JASON CREEK (REID ROAD) ASSESSMENT

PROJECT NO.: 1358009

Re: Jason Creek (Reid Road) Assessment

BGC Engineering Inc. (BGC) is pleased to provide you with this desktop review of the emergency assessment at Jason Creek completed by Cordilleran Geoscience in response to the hydrogeomorphic events of November and December, 2021.

Figure 3-2. Estimated simplified frequency-magnitude (F-M) curves for Jason Creek. F-M curve from Cordilleran (December 13, 2021) is shown in orange, with a power fit shown by the orange dashed line. BGC regional F-M curve shown in blue

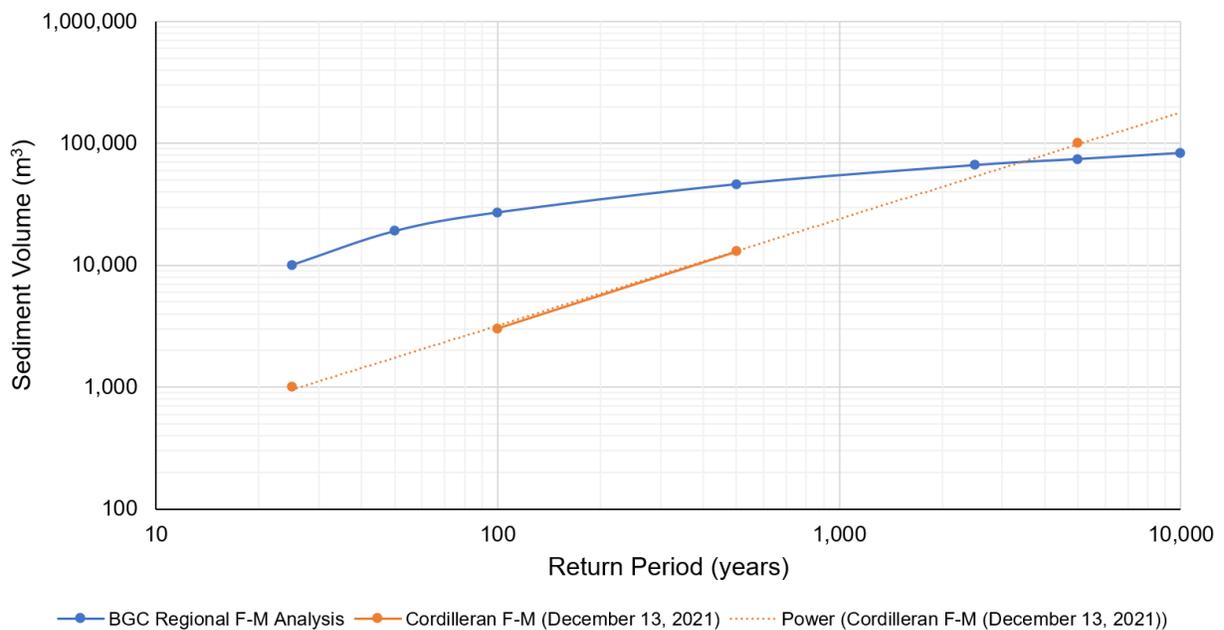
BGC compared the F-M curve presented by Cordilleran to a statistically based, F-M relationship derived from fan-area relationships in British Columbia and Alberta (Jakob et al., 2019). The two curves are shown on Figure 3-2. The BGC regional analysis likely overestimates potential sediment volumes at lower return periods (<100 years) due to the nature of the fan-area relationship fit. This relationship can be better constrained with additional analyses including airphoto interpretation, supplemented with dendrogeomorphological analysis, and test pitting and radiocarbon dating.

In BGC’s opinion, the F-M curves presented in Figure 3-2 should not form the basis for debris-flow modeling or risk assessment as more work would be required improve their reliability.

Specifically, one would need to split up the different triggering events (rainfall triggered, vs. rock slide triggered), which would likely create break points in the F-M curve. This is consistent with Cordilleran's intention as described in their conclusions. The confidence bounds presented on the Cordilleran F-M curve are helpful as they convey uncertainty in the F-M estimates. However, Cordilleran does not explain the width of the confidence bounds.
